## ADDENDUM NO. 1

### Westside Elementary School Roof Replacement

Derthick Henley & Wilkerson Architects

DHW Project No. 8226-E

##### **A101 – Roof Plan**

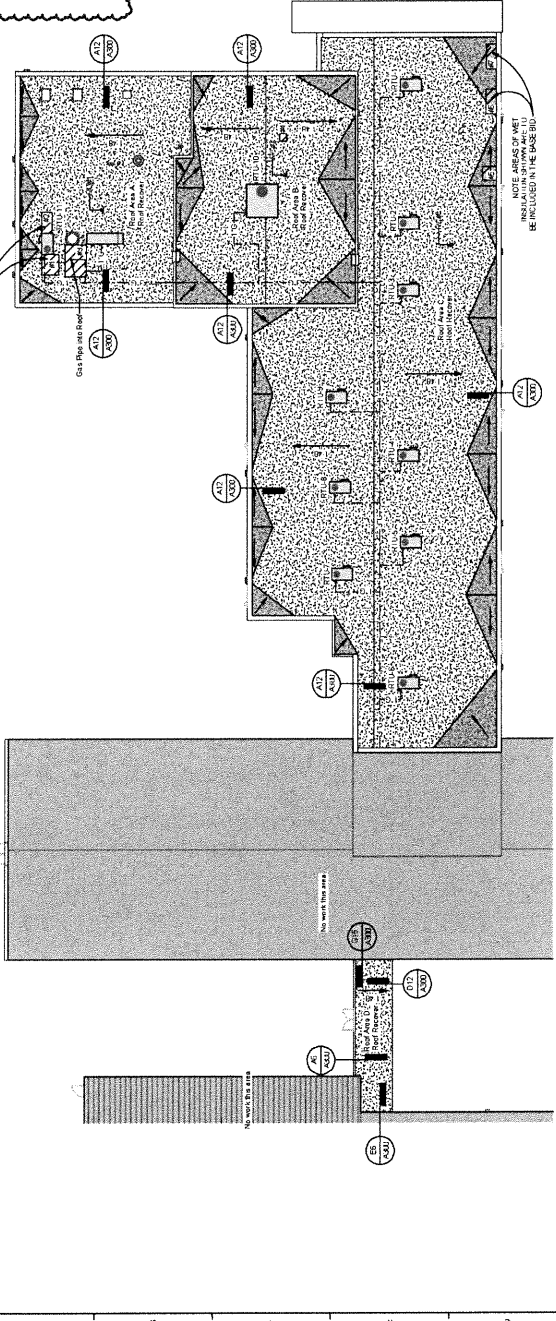
Revise “Roof A & B – Base Bid, Roof Recovery Assembly” and “Roof C & D – Alternate 1) to read:

*80 Mil TPO Roof Membrane (Fully Adhered)*

*1/2" HD Polyisocyanurate Cover Board (Mechanically Fastened)*

*Existing EPDM Membrane (Cut at 10' O.C. Ea. Way)*

*Existing 3" Polyisocyanurate Insulation (Replace where wet)*

*Existing Metal Deck (Sloped)*

Add the following general note:

*Provide walk-way pads on the service side of all roof top units. Field coordinate lengths with RTU dimensions.*
